December 24, 2018

The purpose of this letter is to file the Alaska Forest Association's (AFA) notice of Objections to the Tongass National Forest's proposed Prince of Wales Landscape Level Analysis (POW-LLA) Final EIS and Record of Decision (ROD). The AFA (111 Stedman Street, Suite 200, Ketchikan, AK 99901; (907) 225-6114) is one of the oldest trade associations in the State of Alaska and represents more than 100 members sharing an interest in Tongass National Forest lands and the Southeast Alaska timber industry. As stated in the AFA's June 8, 2018 comments on the POW-LLA Draft Environmental Impact Statement (DEIS), a copy of which accompanies these Objections, the non-profit AFA currently benefits Southeast Alaska by managing a pension program, a group health insurance program, and a scholarship program, along with sponsoring the Sustainable Forestry Initiative program for Alaska. The AFA is committed to the restoration, promotion and maintenance of a healthy, viable forest products industry that contributes to the economic and ecological health in Alaska's forests and communities. Towards that end, I offer the following Objections on behalf of the AFA.

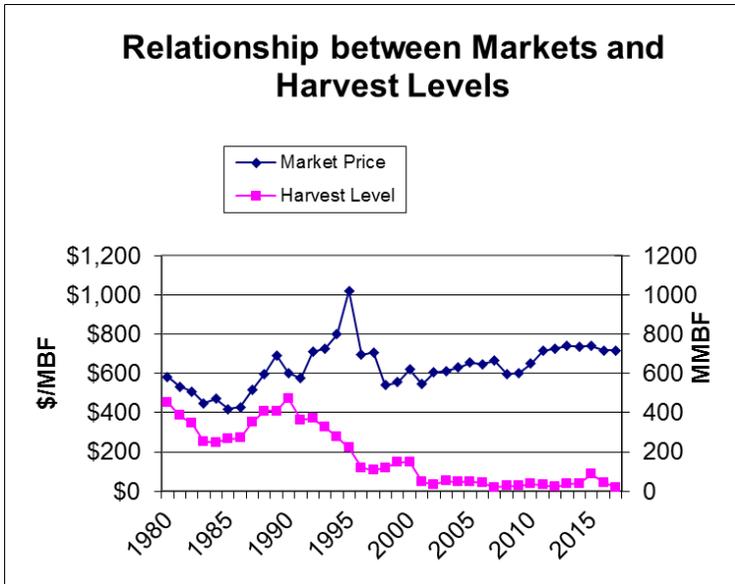
Data from the USFS appraisal shop was used to create the graph below. It is very apparent that the only significant decline in Southeast Alaska timber markets was immediately after the 1994 all-time high pulp market and after the 1997 closure of the last pulp mill. That mill closure resulted in reducing the value of all utility logs in the region (15% to 30% of the total forest) from about \$200/mbf to basically zero. Sawlog markets have been trending upwards since 1997 (coincidentally, dissolving pulp markets have also continued to rise since 1997). The dismal timber sale economics and the constant failure to meet timber targets and implement timber sale projects since 1997 is due almost entirely to the wildlife conservation strategy and other standards and guidelines that were adopted in the 1997 TLMP.
